## **Supplementary Report - Encroachment Appeal 135 Glen Road**

**Date:** May 6, 2024

**To:** Toronto and East York Community Council

**From:** Director, Permits and Enforcement, Transportation Services

## Attachment 3: Landscape Details of Proposed Encroachment No.LD1.0- 135 Glen Road

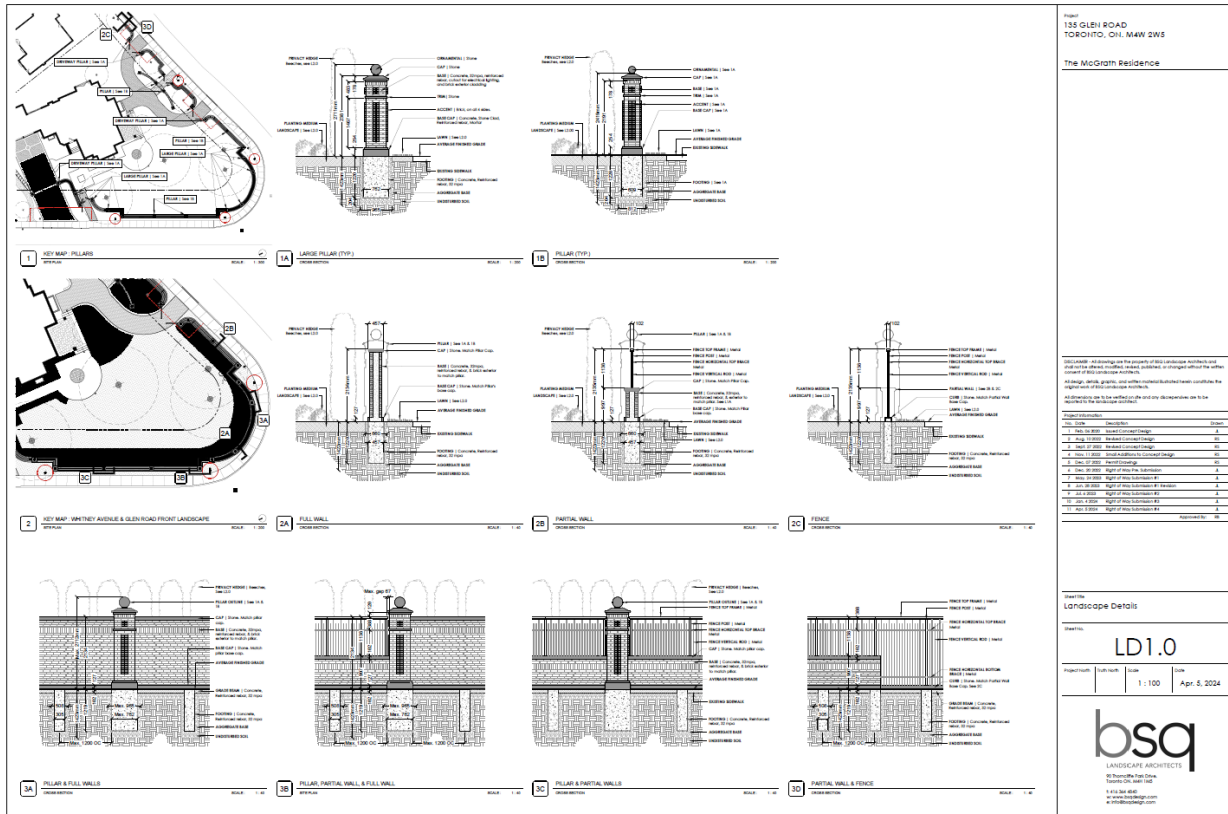
- The proposed stone/concrete/brick privacy walls will be built to a height of 2.1m-2.3m; the pillars will be built to a height of 2.7 metres; and the beech tree privacy hedge will be maintained at a height of 6.1 metres which contravenes Municipal Code Chapter 743 article 743-34A.(2)(a)[1] requirement that "No solid screen fence, privacy fence, railing, bollard, arbour, pergola, ornamental or retaining wall located within 70 metres of the intersection of any two or more streets shall exceed a height of one metre, with the height measured from the surface of the intersecting road"

- The proposed stone/concrete/brick privacy walls will be built to a height of 2.1m and the pillars will be built to a height of 2.7 metres which contravenes Municipal Code Chapter 743 article 743-34A.(2)(a)[2] requirement that " No solid screen fence, privacy fence, railing, bollard, arbour, pergola, ornamental or retaining wall located within three metres of a driveway that is adjacent a sidewalk, or the travelled surface of any road without curbs, shall exceed a height of one metre, measured from the grade of the adjoining driveway".

1. Toronto and East York Community Council authorize the General Manager of Transportation Services to negotiate and enter into an encroachment agreement with property owner(s) of 135 Glen Road, to install and maintain concrete and metal iron fences, automated gates, stone/concrete/brick pillars, and a beech tree privacy hedge, subject to, but not limited to, the following conditions:

- i. Maintain a minimum 1.0 m clearance from existing utility poles and sign posts;
- j. Beech tree privacy hedge to maintain a 3.0 metre clearance from the edge of the driveway; and

## Attachment 4: Landscape Details of Proposed Encroachment No.LD2.0- 135 Glen Road

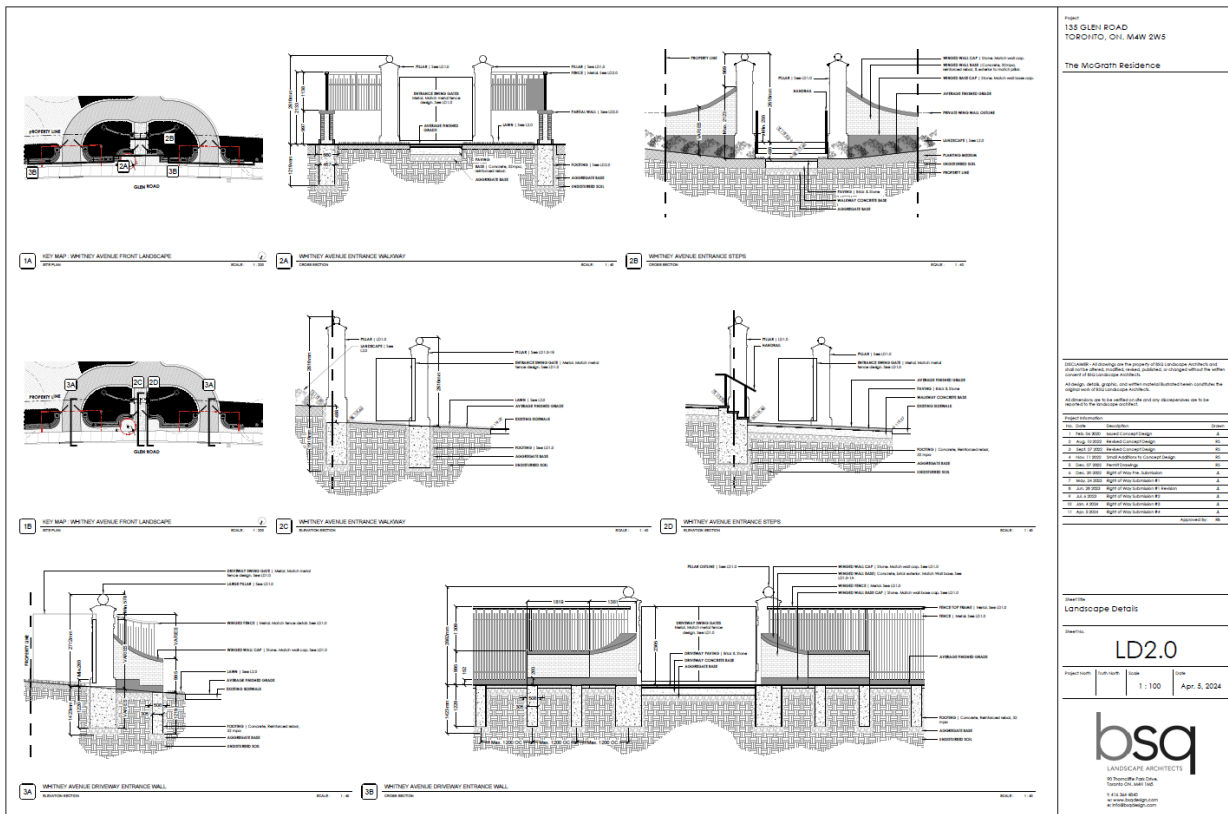
- The proposed concrete and metal iron fence and automated gates will be built to a height of 2.1-2.3m metres and the beech tree privacy hedge will be maintained at a height of 6.1 metres which contravenes Municipal Code Chapter 743 article 743-34A.(2)(a) "A fence located within a street can be built to a maximum height of 1.20 metres for that portion of the fence fronting the property, and 1.80 metres for any fence located in the flankage of the property, provided that to ensure unobstructed driver and pedestrian sight lines"
